**Application No. Mod2023/0554**

**Address: 316 Hudson Parade Clareville**

**Description: Modification of Development Consent DA2020/1762 granted for Demolition works and construction of boatshed, ramp, slipway, jetty & steps**

**SUBJECT: Modifications of Development Consent for Demolition Works and Construction of boatshed, ramp, slipway, jetty and steps – Mod2023/0554**

APPENDIX 1: NORTH ELEVATION OF BOATHOUSE SHOWING HISTORICAL AND PROPOSED LOCATION OF EXTENSION INTO PITTWATER

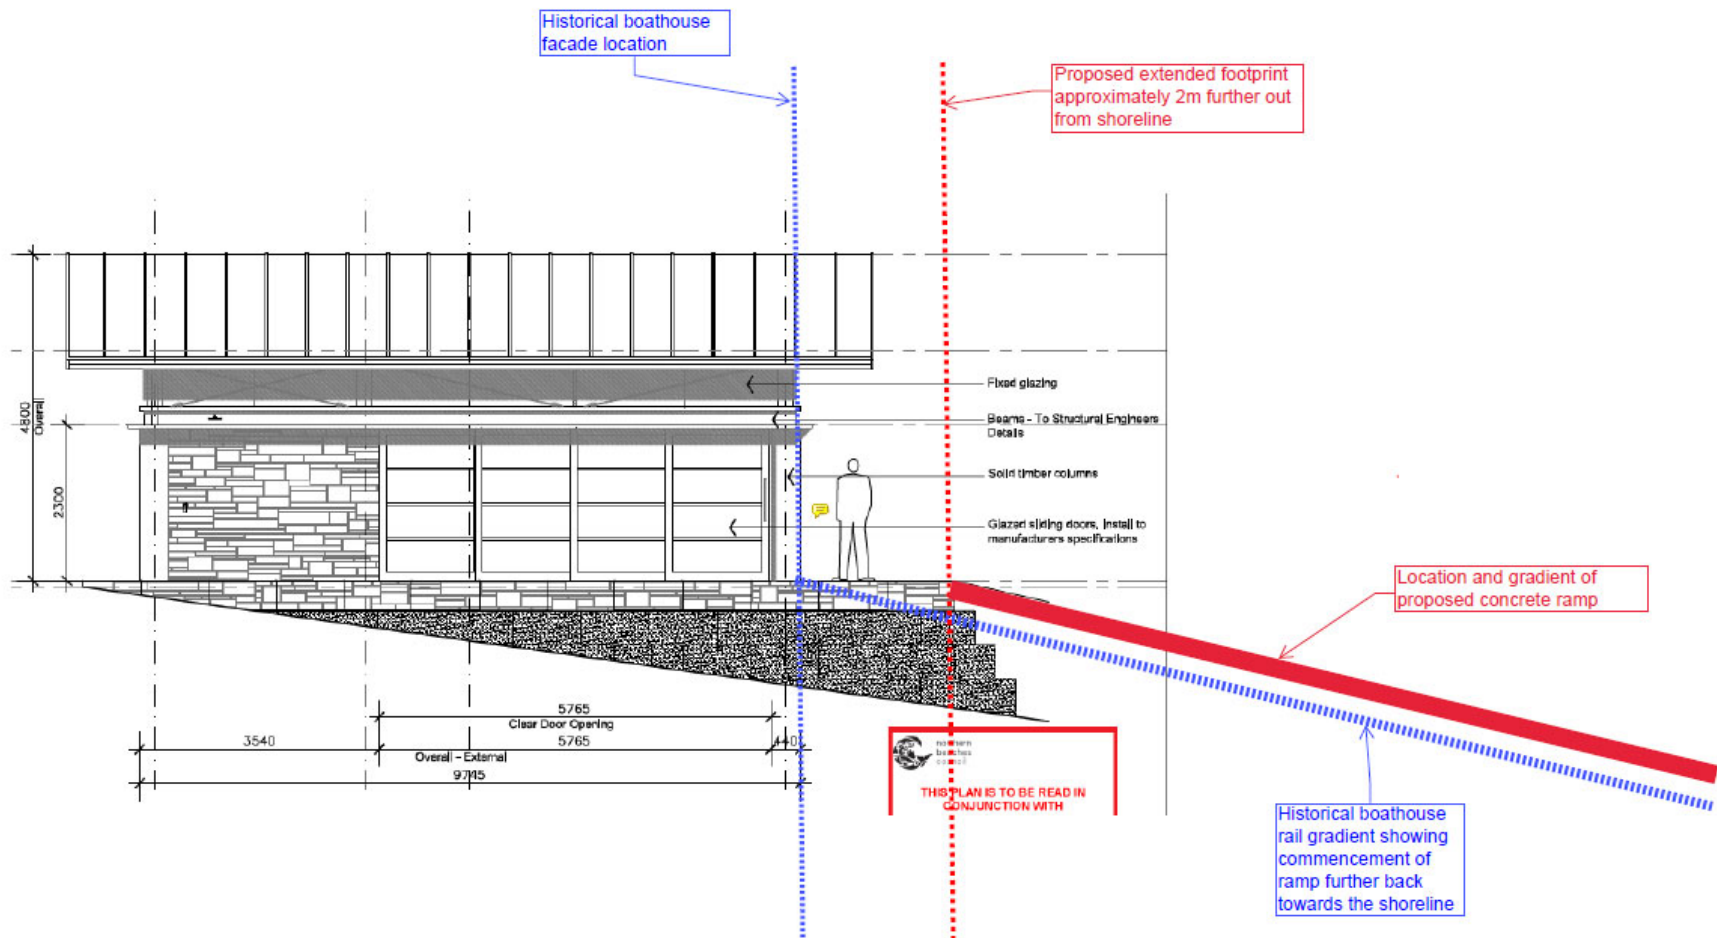
However, this proposal seeks to extend the floor of the boathouse westwards beyond the wall of the boathouse by a further two metres (approximately), prior to the commencement of the ramp (refer **Appendix 1**).

In my opinion, the modern design aesthetic of the 316 Hudson Pde Boat House is not in keeping with the majority of boathouses on Pittwater within 1km either side of this location. It is designed to stand out, rather than be in keeping with its surrounds. Furthermore, the two metre extension of the floor beyond the boathouse, together with the concrete ramp structure significantly:

- increases the mass of the overall building envelope when viewing the west elevation (i.e. from the waterway back to land)
- encroaches into the water way across the shoreline both visually and physically in comparison to the historical boathouse and ramp of the original boathouse that was there for the last 30 years before it was demolished.

**I OBJECT** to the extended footprint and modern design patina proposed for the boat house encroaching a further 2m into the waterway above ground, and ask Council to seek an amended design that restricts the extent and form of the boathouse consistent with the previous boathouse in this location, so that the proposal is in keeping with its bushland shoreline surrounds, and maintains the same north and south viewing corridors along the shoreline of the previous boathouse in the same location.

APPENDIX 2: MARKUP OF PROPOSED BOATHOUSE AND RAMP ON HISTORICAL PHOTO OF ORIGINAL BOATHOUSE

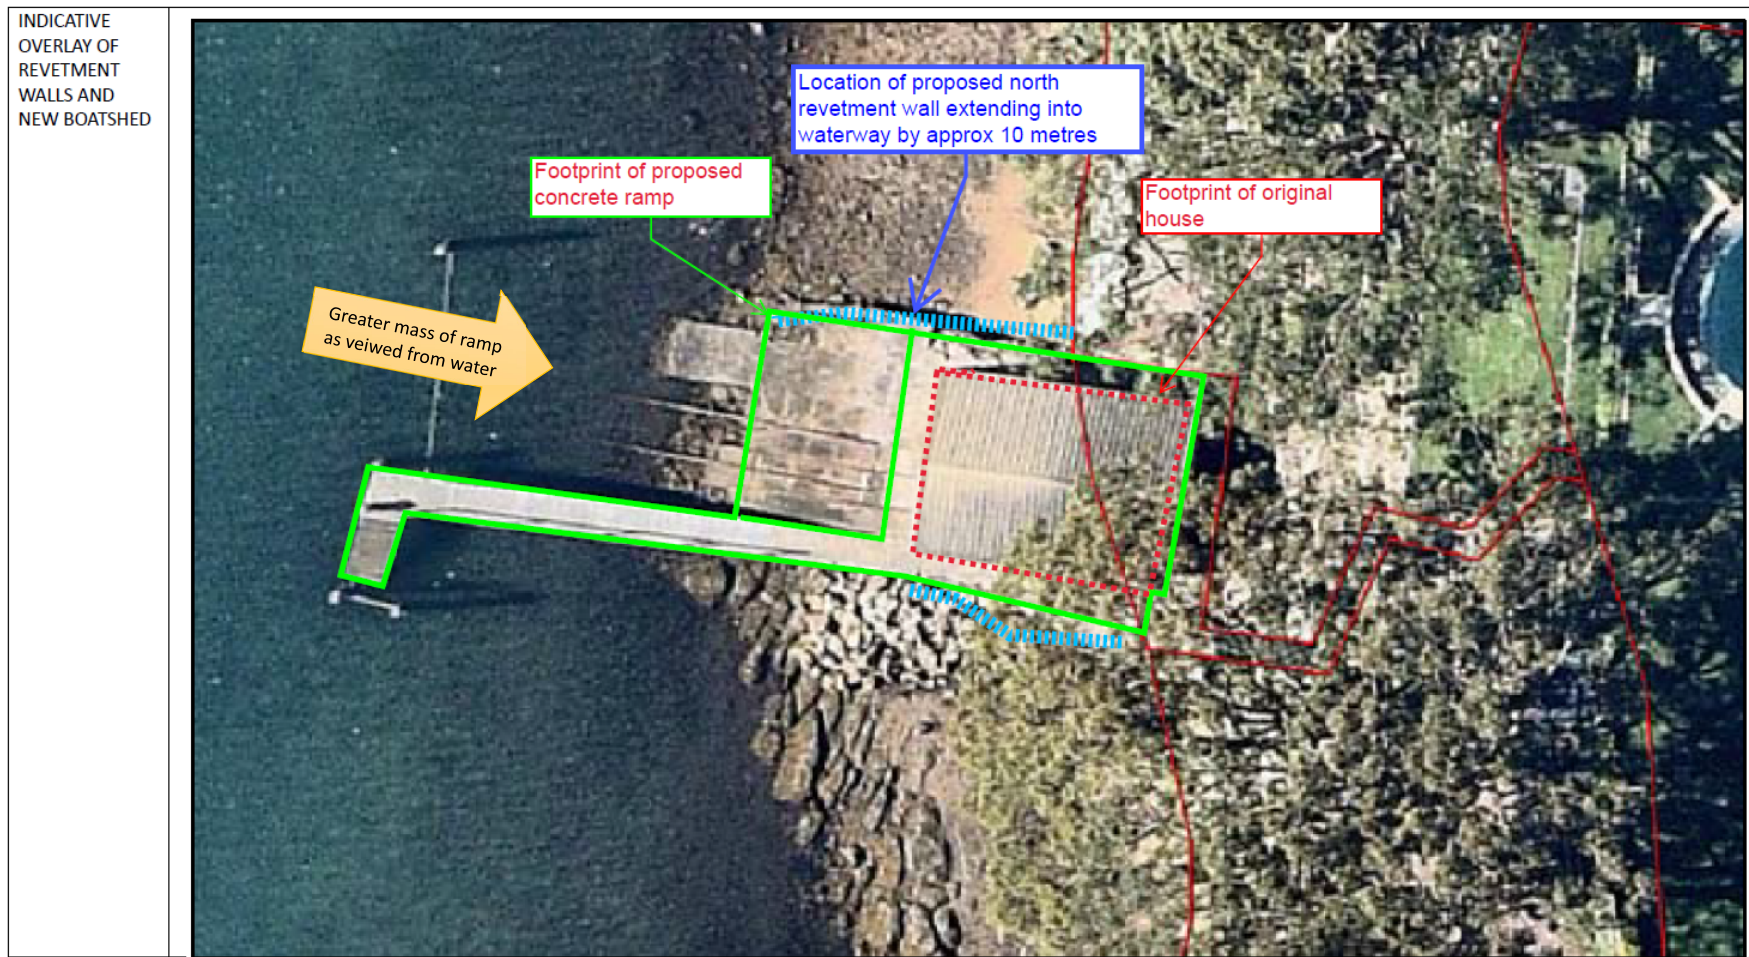
The proposed Boat Ramp is of concrete construction and includes the construction of north revetment wall extending westward at right angles to the shoreline approximately 10m further than the original revetment walls of the demolished boathouse in the same location (refer **Appendix 2**).

The main purpose of the north revetment wall presumably is to protect the concrete ramp structure which encroaches further into the waterway than the previous boathouse ramp in the same location. The ramp extends for the full width of the boathouse (i.e. at least 50% wider than the previous boathouse).

In my opinion, if the boat ramp and revetment wall are constructed in the form proposed, the whole structure will significantly impact the waterflow of the shoreline permanently. That is, the proposed footprint will permanently alter the circulation of water travelling north and southward along the shoreline caused by the longer revetment structure intruding further into the water below the average low water mark than the previous boathouse revetment wall which still exists (as at 6 November 2023).

- mass and footprint of the concrete ramp due to its visual impact looking east to the shore from Pittwater i.e. the grey concrete ramp structure will dominate the shoreline rather than blend in with it, and is more suited to the urban setting of Sydney Harbour, than the bushland character of the shoreline of Pittwater.
- location and extent of the north revetment wall on the basis that it will permanently and irreversibly change the north-south water flow along the shoreline. If modelled, I'm certain that Council will find that the position of the north revetment wall will significantly and permanently scour and scar the shoreline in an unprecedented manner in comparison to the other boat ramps, due to the extent to which the wall intrudes across the low water mark.

APPENDIX 1: NORTH ELEVATION OF BOATHOUSE SHOWING HISTORICAL AND PROPOSED LOCATION OF EXTENSION INTO PITTWATER

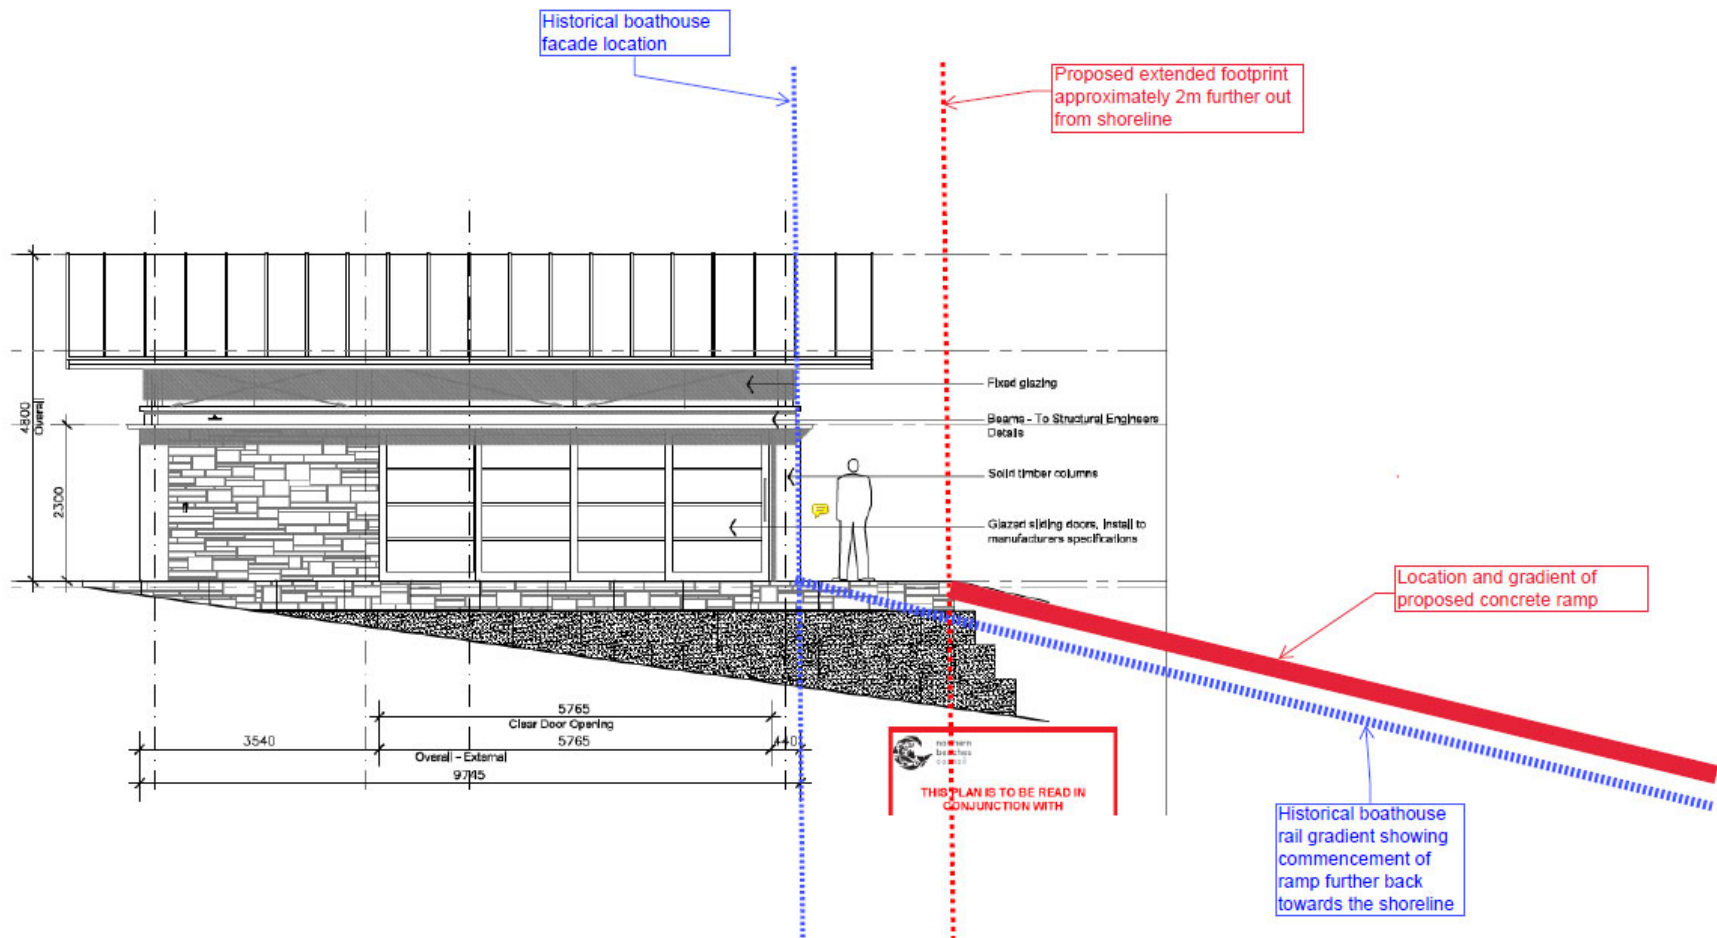
However, this proposal seeks to extend the floor of the boathouse westwards beyond the wall of the boathouse by a further two metres (approximately), prior to the commencement of the ramp (refer **Appendix 1**).

In my opinion, the modern design aesthetic of the 316 Hudson Pde Boat House is not in keeping with the majority of boathouses on Pittwater within 1km either side of this location. It is designed to stand out, rather than be in keeping with its surrounds. Furthermore, the two metre extension of the floor beyond the boathouse, together with the concrete ramp structure significantly:

- increases the mass of the overall building envelope when viewing the west elevation (i.e. from the waterway back to land)
- encroaches into the water way across the shoreline both visually and physically in comparison to the historical boathouse and ramp of the original boathouse that was there for the last 30 years before it was demolished.

**I OBJECT** to the extended footprint and modern design patina proposed for the boat house encroaching a further 2m into the waterway above ground, and ask Council to seek an amended design that restricts the extent and form of the boathouse consistent with the previous boathouse in this location, so that the proposal is in keeping with its bushland shoreline surrounds, and maintains the same north and south viewing corridors along the shoreline of the previous boathouse in the same location.
